MOSCOW MILL HOUSE

10 - PROPOSED ELEVATIONS

REV.	DESCRIPTION	DATE	BY	CHKD
P1	FIRST ISSUE	28-03-21	SG	SG
P2	SIDE GLAZING INCLUDED	30-03-21	SG	SG
P3	revision as per conservation officer concerns	15-07-21	SG	SG

fully weathered cladding on the existing barn

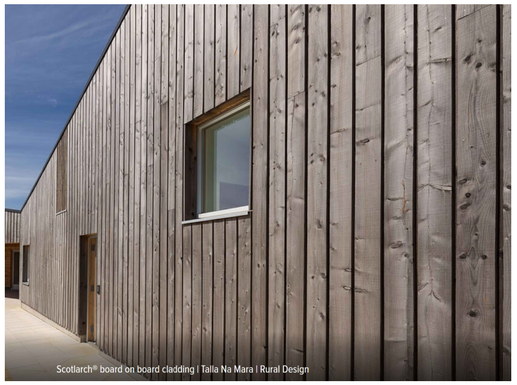
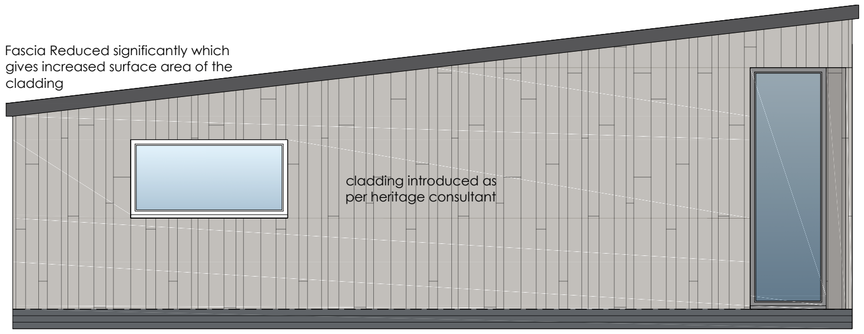
A 'lightweight' solution with Timber cladding has been applied instead of stone.

Siberian Larch or a very similar timber to match the existing is adopted with a vertical paneling effect, with staggered joints as shown.

The Larch which will weather down well that will match the Barn.

The finish to the timber will be natural with no staining.

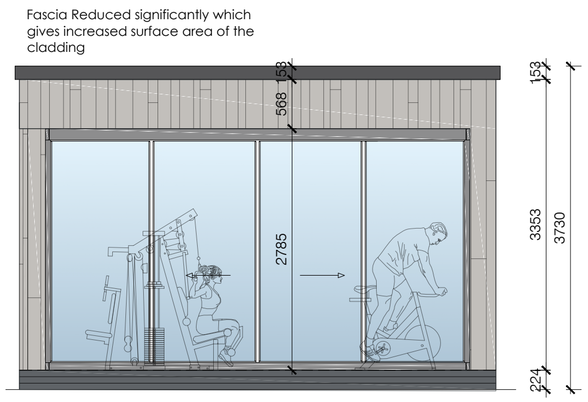
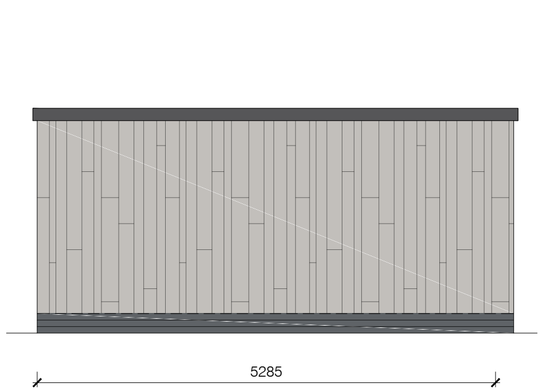
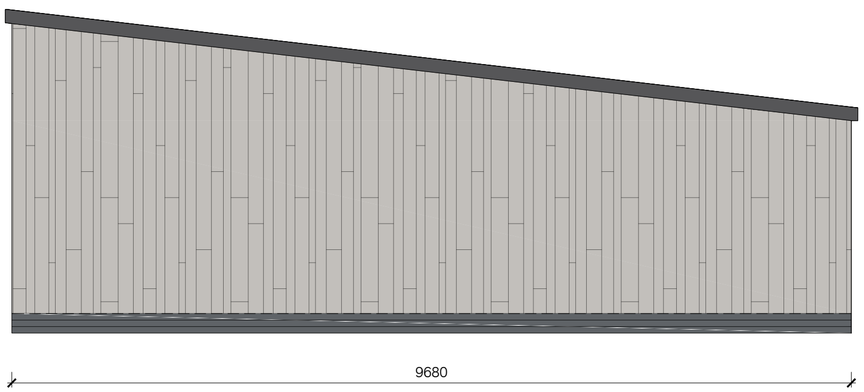
As suggested by the conservation officer, we re-visited the glazed end wall, with its single panel return to the remaining open part of the barn.

The suggestion has been raised to install concealment hit and miss.

We have assessed and ran over the suggestions, but we really need the glazing is to remain as the original drawings for this to be fit for purpose.
This is for numerous reasons which we hope you will consider in new light, as the updated elevation drawings show the staggered cladding and amended fascia and definitely creates a different feel.

- The front elevation is east facing and within the use as an office / gym - this natural light is critical
- The corner window is to allow the light in as the sunlight moved into the southern position.

Having timber concealment will in essence create a large dark box.

The alterations in the cladding and reducing the fascia down has certainly played down the glazing somewhat anyway. As there is more volume of timber panelling instead of the fascia.

The deep fascia following the roof slope was a prominent feature. As mentioned above, we completely agree that this should be altered.

- Together with the cladding a reduced trim to approx 150mm in a matching timber to the paneling will reduce the prominence significantly.
